ADDENDUM

PROJECT: Lincoln Public Schools
Lincoln Northeast High School
Fitness Center Addition
Lincoln, Nebraska

AD-1

DATE ISSUED: Tuesday, January 5, 2016

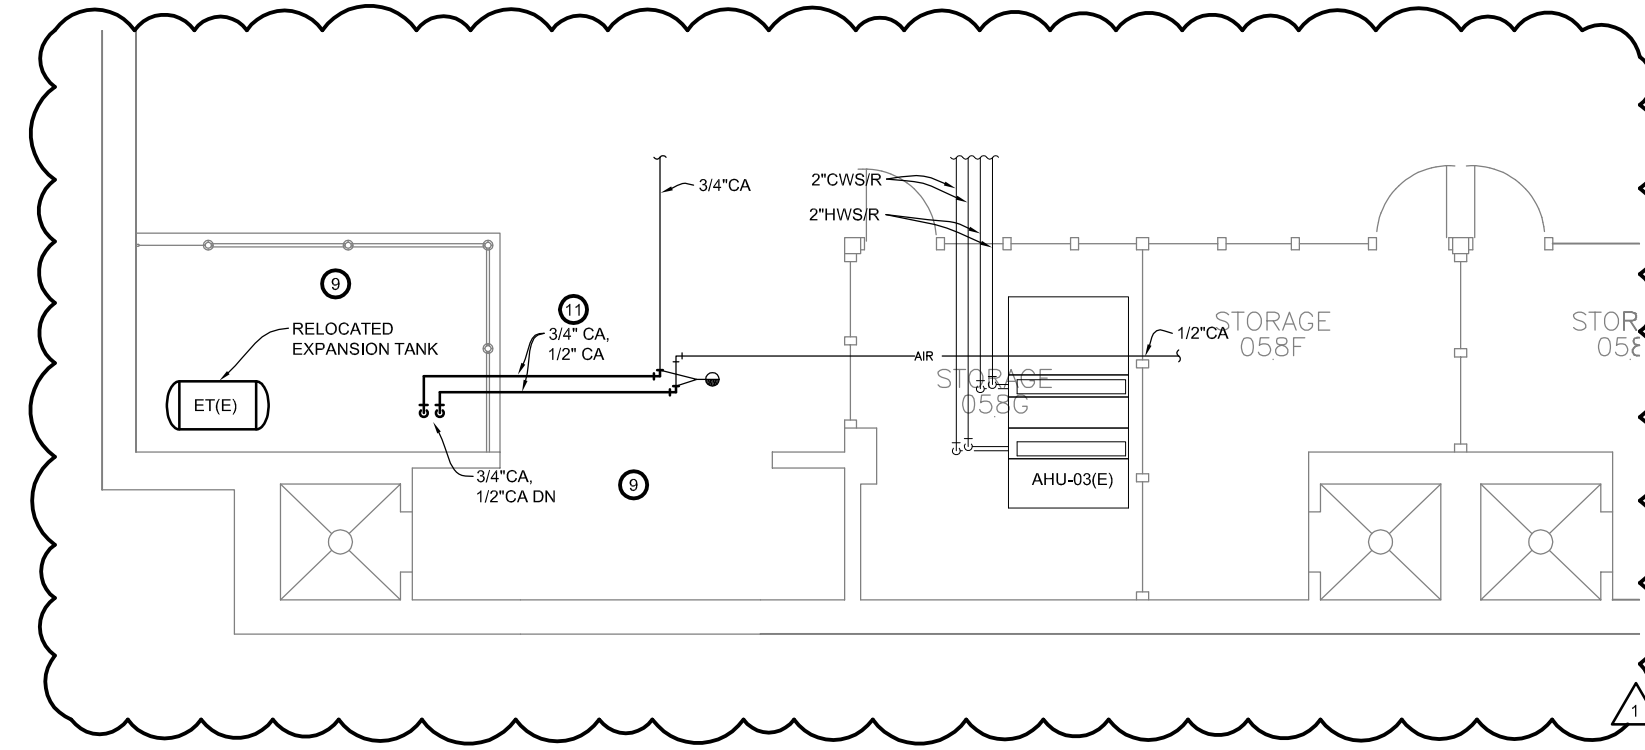
In reference to Sheet C-102 – Construction Plan, delete note along west side of shop overhead door entrance indicating “re-located water line.”
